Subject: Brunswick Steam Electric Plant, Unit Nos. 1 and 2
Docket Nos. 50-325, 50-324
Response to NRC Request for Additional Information Regarding Diesel Generator
(DG) Completion Time (CT) Extension for Technical Specification (TS) 3.8.1, "AC
Sources - Operating" (TAC NO. ME8893 and ME8894)

Response to Request for Additional Information

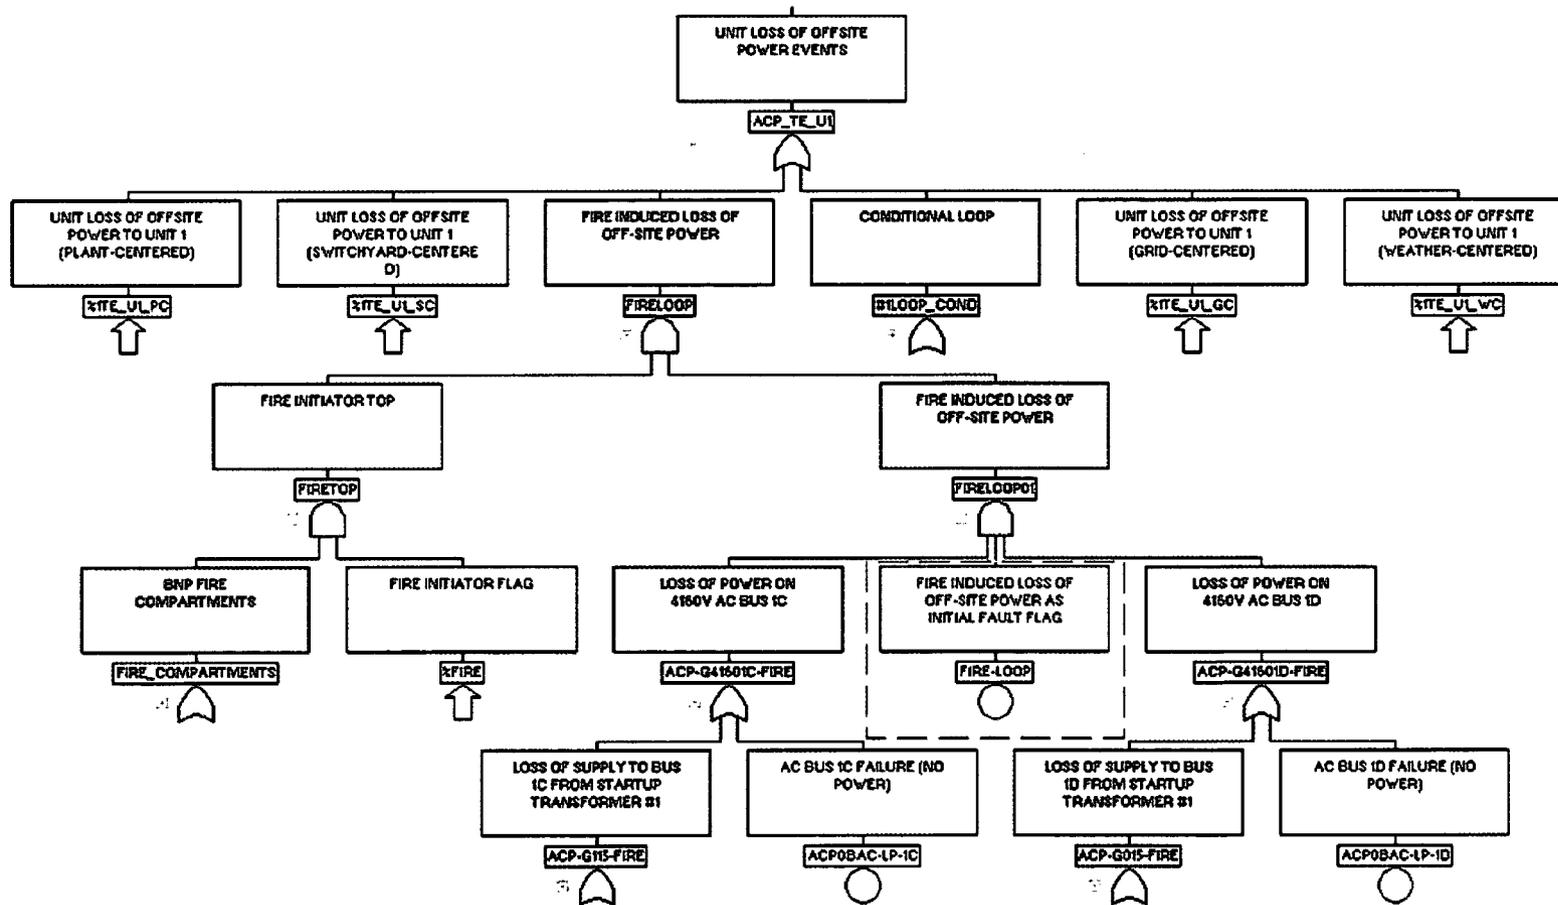
Enclosure 7, page 83, of the LAR lists examples by the peer review of omitted justifications for several partitioning elements that lack fire resistance rating. If applicable, provide justification or clarification for partitioned elements that lack fire resistance rating for fire areas that involve diesel generators or the supplemental diesel generator.

BNP-PSA-083 provided the technical basis to justify crediting the partitioning elements of these Fire Compartments as being capable of substantially containing the damaging effects of fire and documented the walkdown to confirm the existence and integrity of the credited partitioning features/elements. In particular, BNP-PSA-083 described a review of Fire Barrier Drawings and General Arrangement Drawings which indicated that all concrete wall/ceilings/floors credited by the Fire PRA Model (FPRA) were greater than four inches thick. These were comparable to the four inches thick concrete wall that was cited, in Section 1.5.2 of NUREG/CR-6850, Volume 2, as an example of an adequate partition for defining a one-hour fire endurance rating in the Fire PRA context. Also as documented in BNP-PSA-083, the walls formed of the concrete block required by BSEP Design Specification 029-001 were credited with a fire resistance rating of 2 hours, based on the National Concrete Masonry Associated TEK 7-1C.

The supplemental diesel generator is located northwest of the plant in an outside area which comprises, together with other outside areas, Fire Compartment FC263. The primary partitioning element for structures and equipment located in Fire Compartment FC263 is spatial separation. As evident from EC 87088, the supplemental diesel generator is separated from other structures and equipment of interest by at least 30 feet.
